*The Reno Creek ISR Project
Campbell County, Wyoming*

**Revised RAI Response Package:
Technical Report**

December 2014

10288 West Chatfield Ave., Suite 201
Littleton, Colorado 80127-4239 USA
303-290-9414
www.petrotek.com

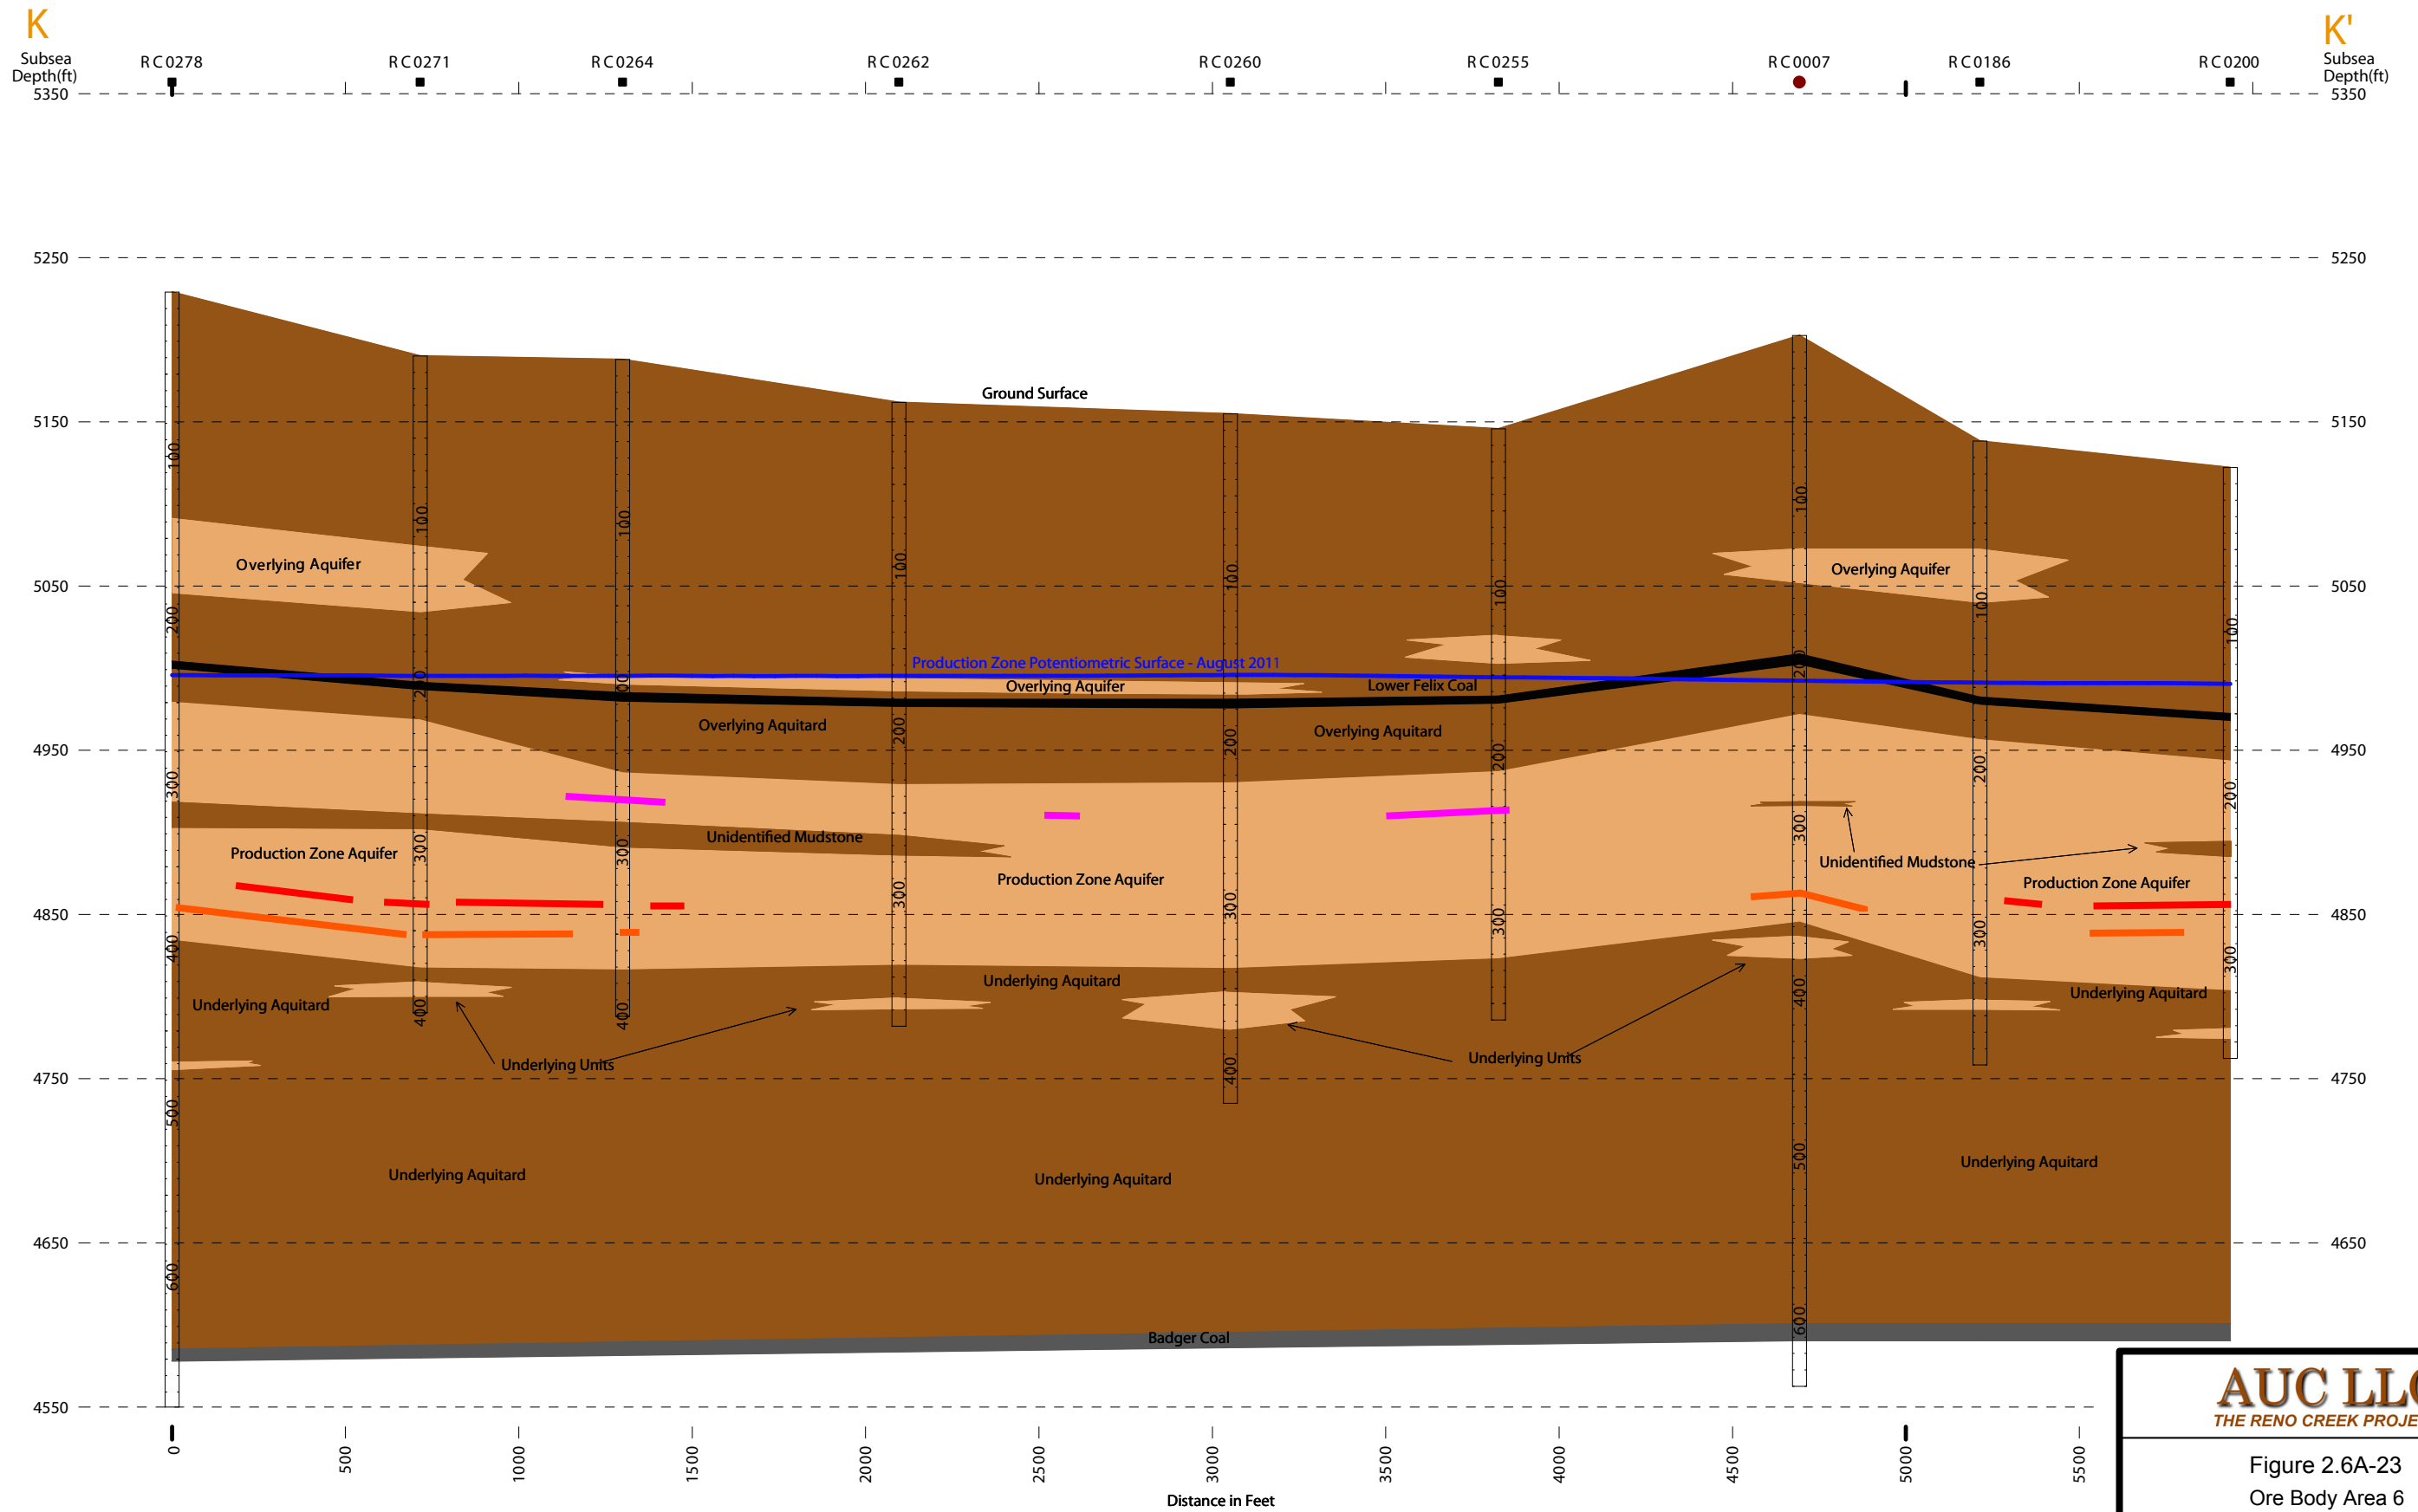
- a) Please provide mapping (including depicting the ore body on the cross-sections) that demonstrates the ore trends including the oxidation and reductions zones.*
- b) Please clarify whether or not Figure 2.6A-17 displays all ore-trend labels, including oxidation and reduction zones.*

On Figure 2.6A-27, the application presented a cross-sectional view of a typical roll front; however, the application did not include cross-sectional views of the ore body within the production zone aquifer throughout the project area (e.g., Figures 2.6A-18 through -23).

“At various localities within the Proposed Project area all horizons from the base to the top of the host sandstone (PZA) can be favorable for uranium deposition. However, economically significant uranium mineralization occurs most frequently in the lower half of the PZA. This relationship and **depiction of the ore trends, including oxidation/reduction boundaries is shown on Figure 2.6A-17. Cross sections depicting the vertical stacking of the ore trends are included as Figures 2.6A-18 through 2.6A-23.**”

Figure 2.6A-17 and Figures 2.6A-18 through 2.6A-23 are shown below:

Figure 2.9-1

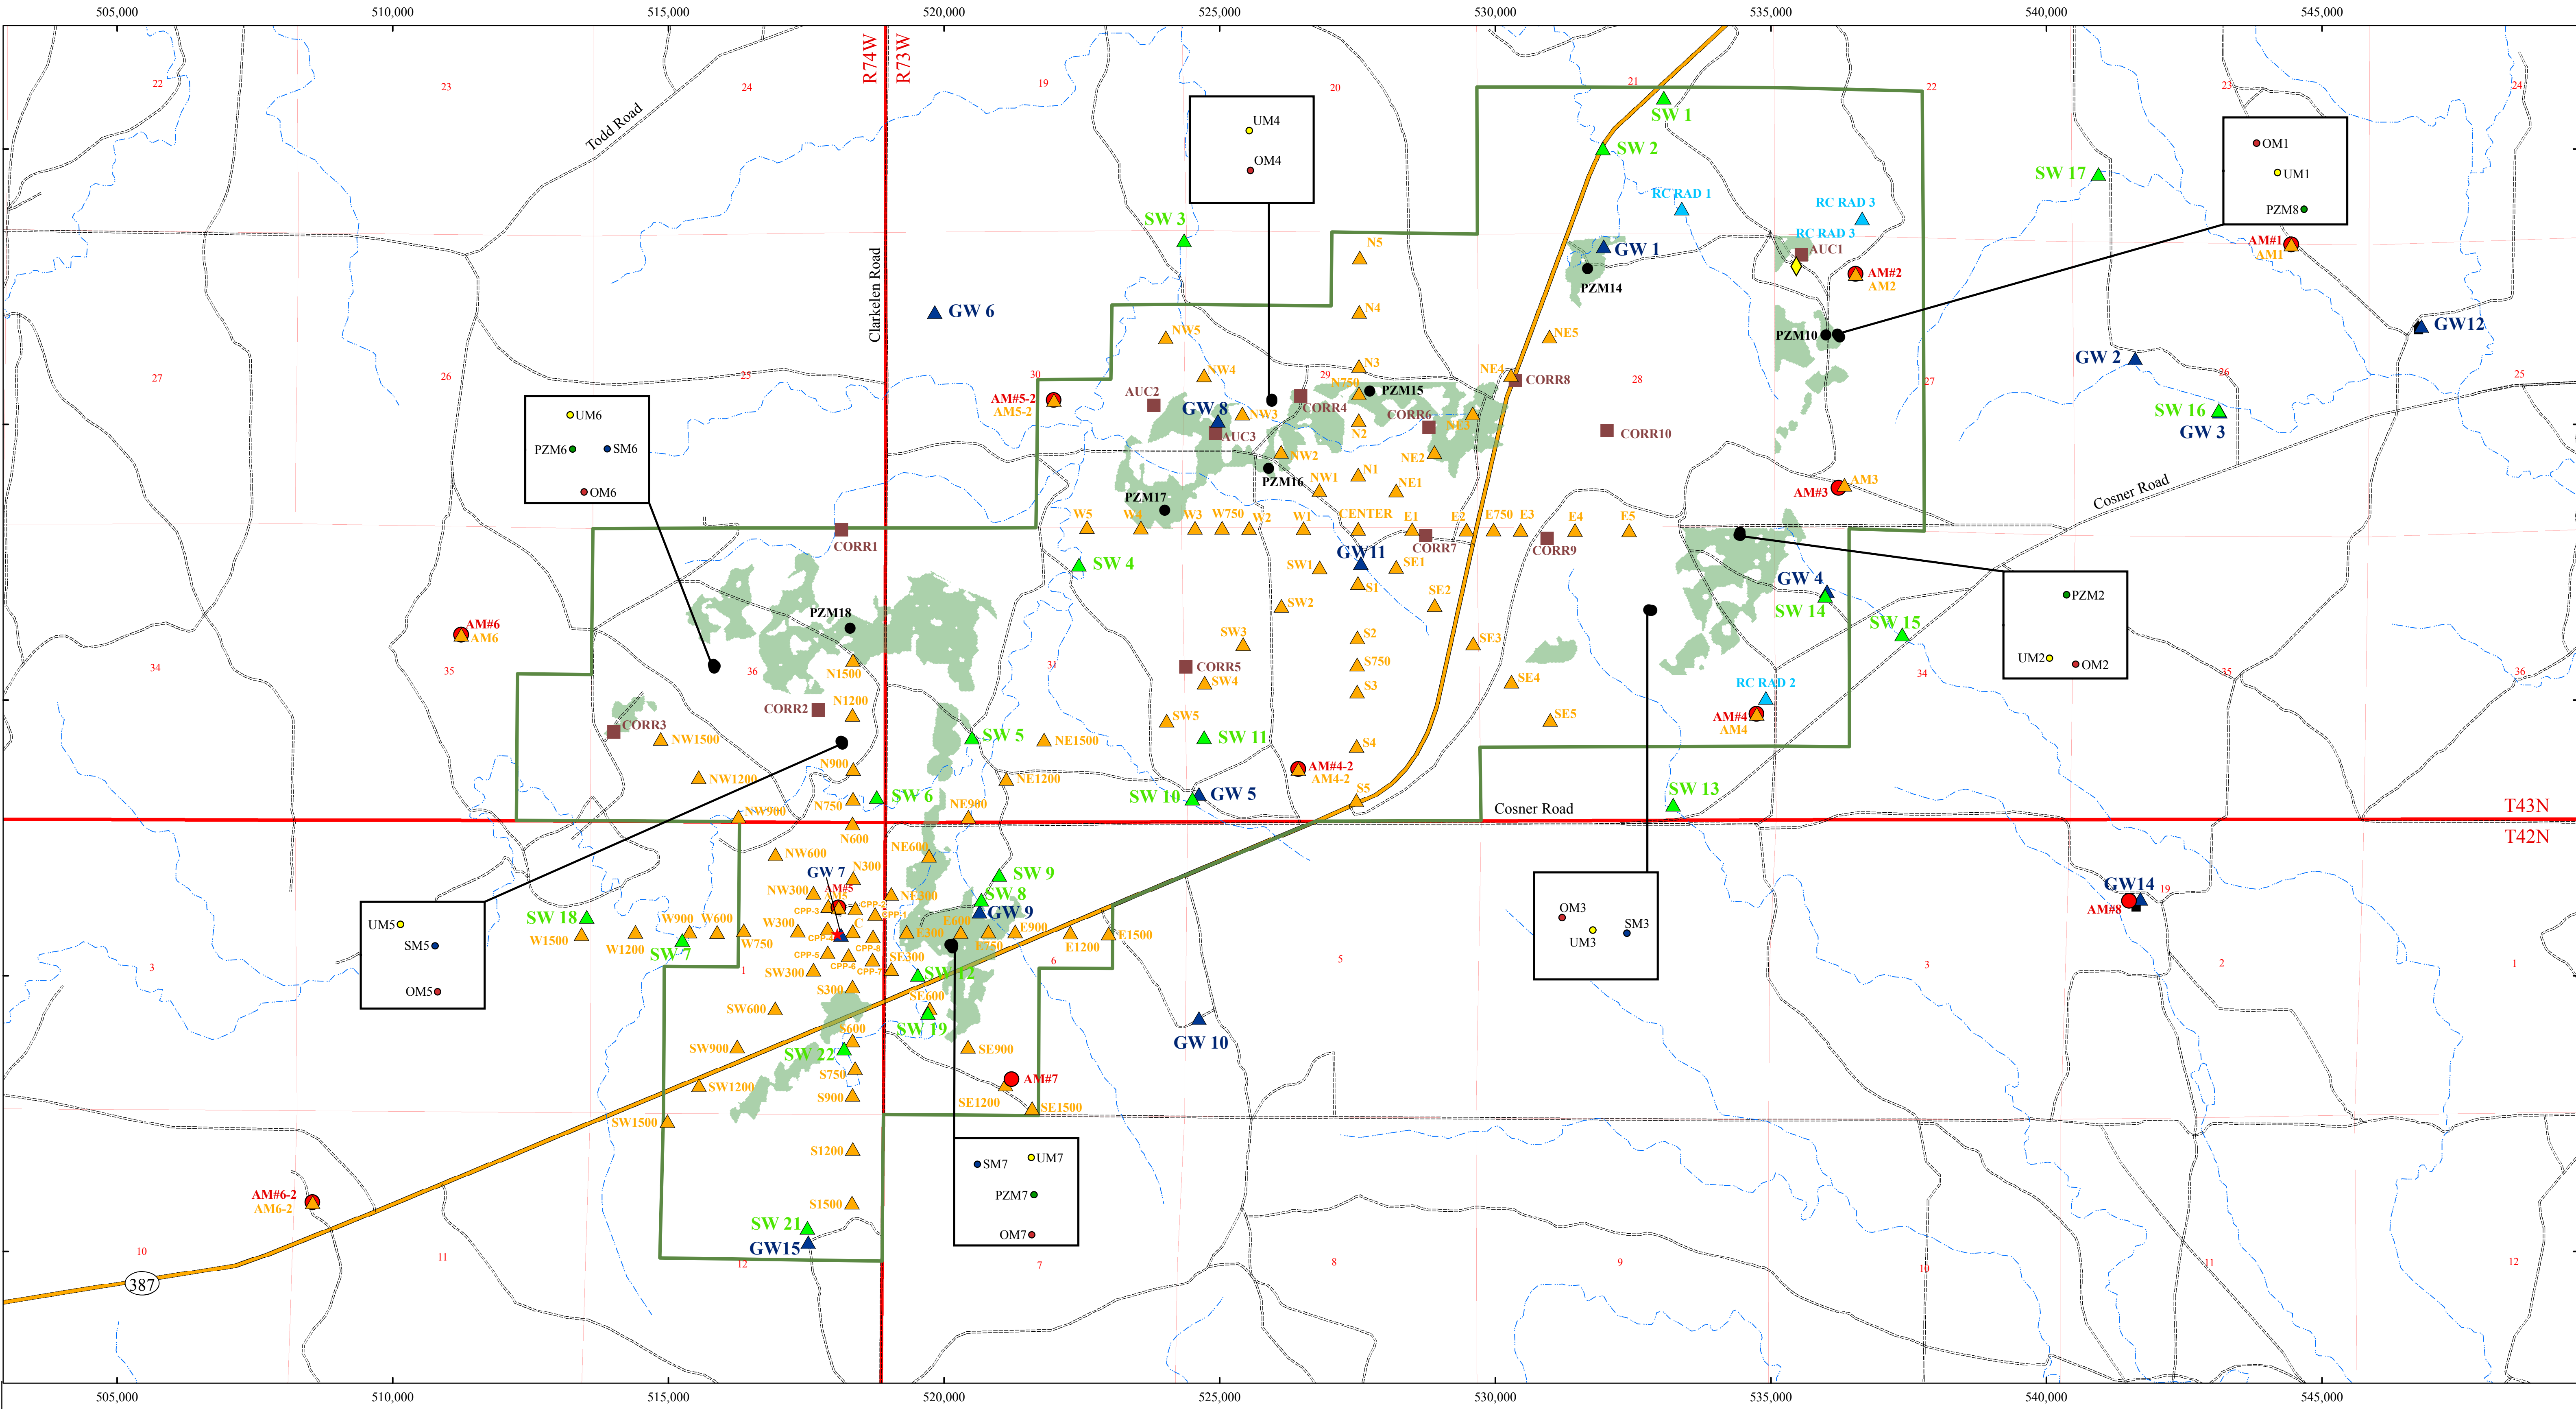
NRC staff noted that the locations of the pre-operational soil (and direct radiation measurements) are not collected around the center of the mill operations (or central processing facility) in Figure 2.9-1. The location of the central processing facility is considered to be the origin of the coordinates and the bases for the location of air particulate, air radon, soil, and direct radiation measurements. Regulatory Guide 4.14, Table 1, recommend surface and subsurface soil samples taken at various intervals from the center of the milling area. Also, SRP Acceptance Criteria 2.9.2(1), which references Regulatory Guide 4.14, Section 1.1, states that three locations at or near the site boundaries in different sectors that have the highest predicted concentrations of airborne particulates, and preoperational sampling should be the same as operational locations. This guidance affects air particulate, air radon, soil, and direct radiation pathways for both pre-operational and operational programs.

NRC staff reviewed Figure 2.9-1 and determined that the pre-operational soil sampling locations are not conducted from the center of the central processing facility. Thus the proposed air particulate, air radon, soil, and direct radiation measurements are not in the proper sampling locations. The central processing facility, as shown in Figure 2.9-1, is located at a different location. NRC staff has determined that the origin of the location of the central processing facility in Figure 2.9-1 impacts the location of the air particulate sampling locations shown in Figure 2.9-1, as well as air radon, soil, and direct radiation during operations. The applicant needs to conduct pre-operational soil sampling from the origin of the location of the central processing facility, as shown in Figure 2.9-1, and develop air particulate sampling locations, based on wind rose data collected during pre-operations from this point of origin. Pre-operational soil samples need to be collected at various intervals from the center of the milling area consistent with Regulatory Guide 4.14 or if the applicant proposes other locations, the applicant must provide its rationale for staff's consideration.

NRC staff reviewed the vegetation sampling locations (RC-RAD-1, RC-RAD-2, and RC-RAD-3) in Figure 2.9-1 of the TR and determined that these vegetation sampling locations are not in three different sectors that will have the highest predicted air particulate concentrations during operations. Regulatory Guide 4.14 states that forage vegetation should be sampled at least three times during the grazing season in grazing areas in three different sectors that will have the highest predicted air particulate concentrations due to milling operations.

AUC's CPP location as given in the application was finalized after the soil sampling for radiological materials had been conducted, and reported in TR Figure 2.9-1. Subsequent to the submission of the application, AUC sampled around the operative CPP location and a revised Figure 2.9-1 (shown below) has been inserted into TR Sec. 2.9 showing changes associated with the relocated CPP.

AUC completed additional soil sampling in 2013, consistent with Regulatory Guide 4.14, for surface and subsurface soils. The pattern of soil sampling locations is shown in revised Figure 2.9-1. Revised Tables 2.9-4 and 2.9-5 present summary statistics for the surface and subsurface soil sampling data. Revised Table 2.9-6 presents radionuclide soil concentration data for the surface and subsurface samples. These tables have been inserted into TR

AUC commits to performing air particulate, radon and gamma monitoring using the same revised set of monitoring locations (as depicted in revised Figure 2.9-1) during licensed operations at the Reno Creek facility. The revised text and tables have been inserted into TR Section 2.9 within the application and are all shown below:

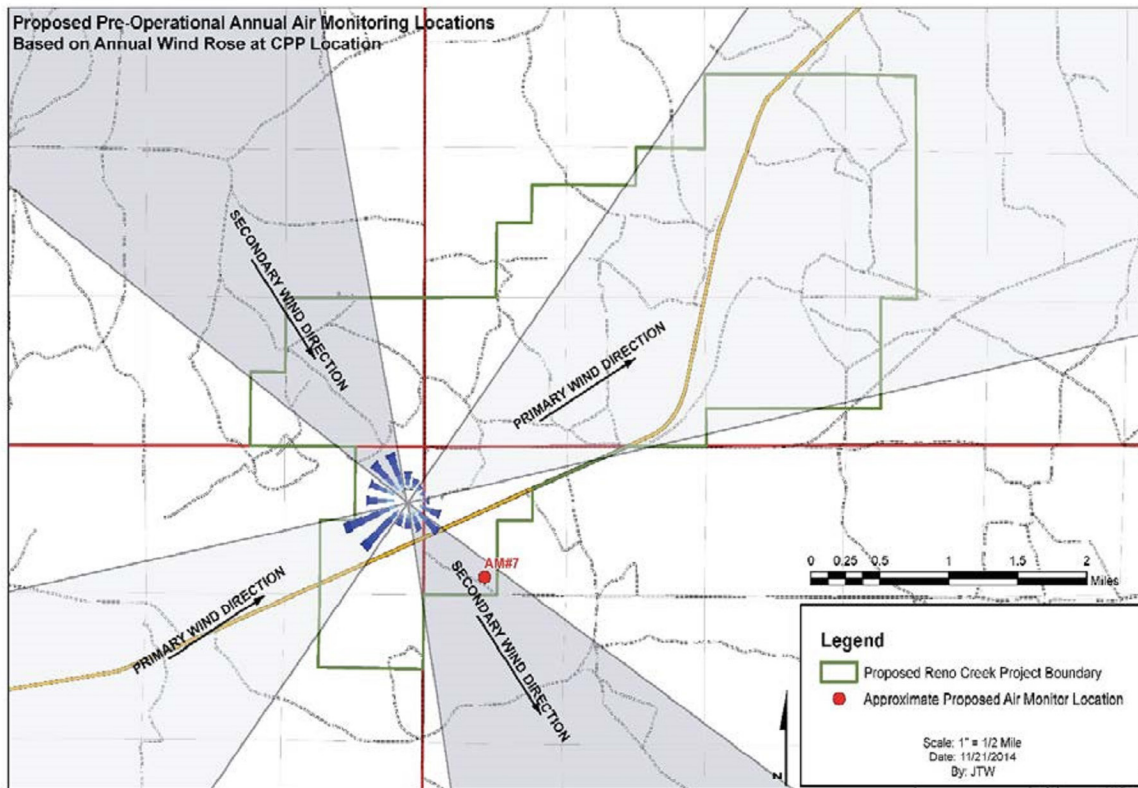
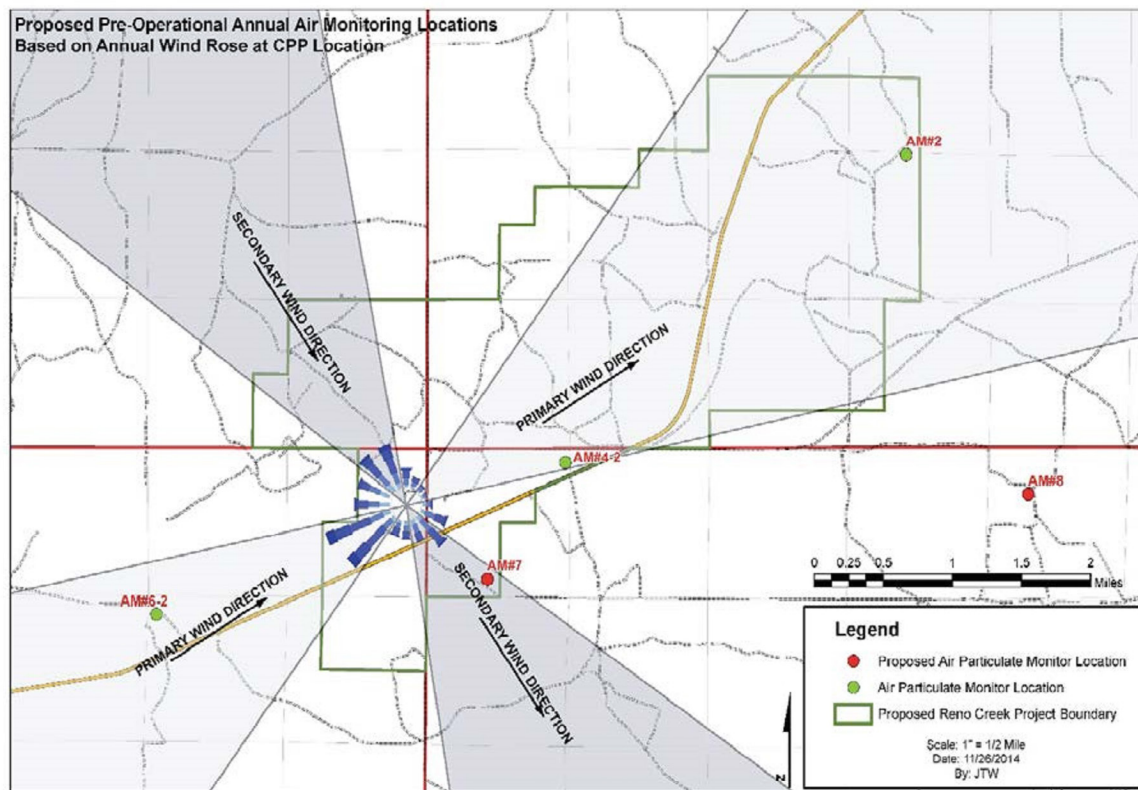
Subsequently, NRC staff requested that AUC review the locations of the air sampling stations to ensure that the new locations conform to Regulatory Guide 4.14, Table 2, Operational Radiological Monitoring Program for Uranium Mills. Specifically the reviewer requested that AUC make sure that three of the air sampling stations are located at or near the site boundaries in different sectors that have the highest predicted concentrations of radioactive materials. Regulatory Guide 4.14 requires that these locations take into account not only the prevailing wind direction, but also the distance from the source (CPP). In order to fulfill this requirement, one of the air sampling stations could be located in a sector with a less dominant wind direction but closer to the source point.

AUC has reviewed the current air sampling stations locations and has determined that air sampling station AM#5-2 is not in a location that meets the above listed requirements from Regulatory Guide 4.14. Therefore, AUC proposes relocating this air sampling station to a location southeast of the CPP in Section 6 of T42N, R73W near the proposed Project Boundary. The sampler will be renamed AM#7. The proposed approximate location of AM#7 is shown on the figure below. This location is in the vicinity of the highest dose predicted by the preoperational MILDOS model results, included as TR Addendum 7-A of the application.

The figure below shows the proposed final air sampling locations that will have been used for pre-operational air sample data collection and will continue to be used to collect data at the same locations during operations.

Air sampling station AM#6-2 is the control (background) station and AM#8 air sampling station will become the nearest residence station. In addition to air particulate sampling, these stations will include monitoring for direct radiation and radon, and soil sampling as specified in Regulatory Guide 4.14. AUC has revised TR Figure 2.9-1 to include the proposed approximate locations of AM#7 and AM#8.
